TECHNICAL BULLETIN

Heated Windshield Washer (Screenwash) Jets – Ambient Temperature Sensor Added – Service Action S447

MODEL XJS Range 1994 - 1995 MY DATE 12/94

84-12
Amended
1/95

ILLUSTRATION 1

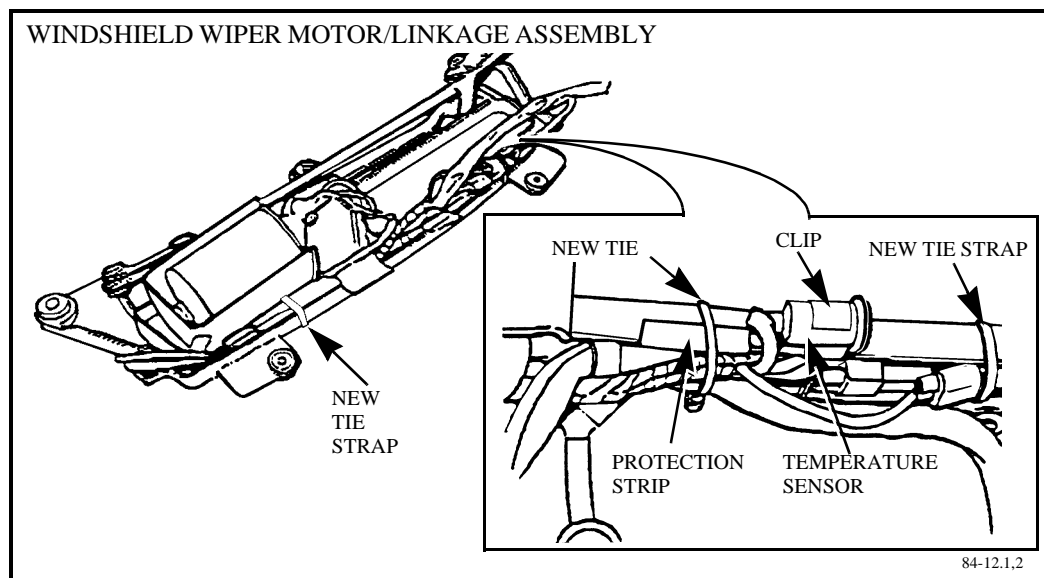
1. Ensure that the radio code is available. Record all preset radio stations (including X-mem) and disconnect the negative cable of the battery.
2. Remove the windshield wiper motor/linkage assembly following the instructions in the XJS Service Manual section 84.15.12.
3. Cut the tie straps, remove and discard the washer jets and the washer jet link harness.
4. Fit the temperature sensor clip and chafing protection strip to the wiper motor/linkage assembly frame (Illustration 1).
5. Route the new washer jet link harness and fully seat the temperature sensor under the clip.

6. Fit new washer jet assemblies, connecting them to the washer fluid lines and the link harness.
7. Connect the link harness to the wiper harness multi plug and fit the “blanking plug” to the open connector of the link harness (red and black wires).
8. Position the washer jets with the link harness and washer fluid lines in the frame channels.
9. Use three tie straps, in the positions indicated in Illustration 1, to secure the washer fluid lines and link harness.
